DIAMONDHEAD FIRE PROTECTION DISTRICT

Re: The Preserve Phase 2 Sketch Plat

PLAN REVIEW

The Preserve PH 2 Sketch Plat

**FIGURE D103.1
DEAD-END FIRE APPARATUS ACCESS ROAD TURNAROUND**

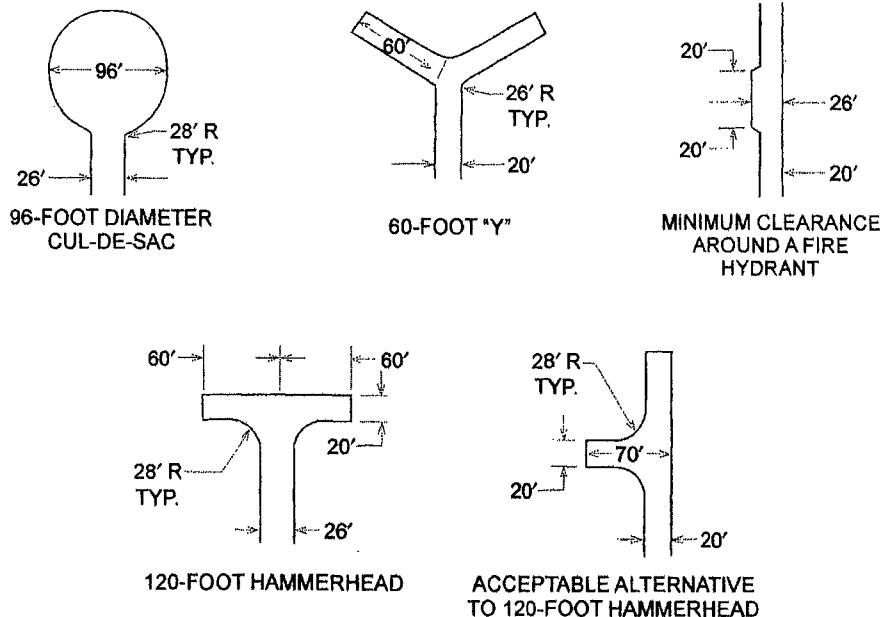
The Fire District's two main concerns with this project are access for fire apparatus and water supply. The reference material in evaluating these features is the International Fire Code 2012. Section 503 addresses Fire Apparatus Access Roads, the roads shall have an unobstructed width of not less than 20 feet and clearance of 13 feet 6 inches. I understand at this time there are only 25 plots shown for development and that falls under the requirement for dual access. The Fire District would like to make sure that we do not end up with a situation where that number is expanded past the 30 unit limit without a secondary access road or the buildings should be sprinklered. The other issue I could not evaluate from the sketch plan was the hydrant spacing and flow capability. Hydrants should not be more than 500' apart by road distance. This would be measured from the nearest hydrant on Diamondhead Drive West not the entrance to the development. The minimum flow requirements for hydrants, per section B105, is 1000 GPM for one and two family dwellings less than 3600 ft². Lastly, on access for turning around. The cul de sac needs to be at least 96 feet in diameter. The dead end either needs a temporary turn around, suitable for fire apparatus, until the street is finished through to Highpoint Dr or the bulge in the road near lots 2,3, and 4 needs to be large enough to allow our Ladder truck (36') to turn around in a "T" type maneuver (see attached graphic fig. D103.1). Thank you for keeping us in these discussions.
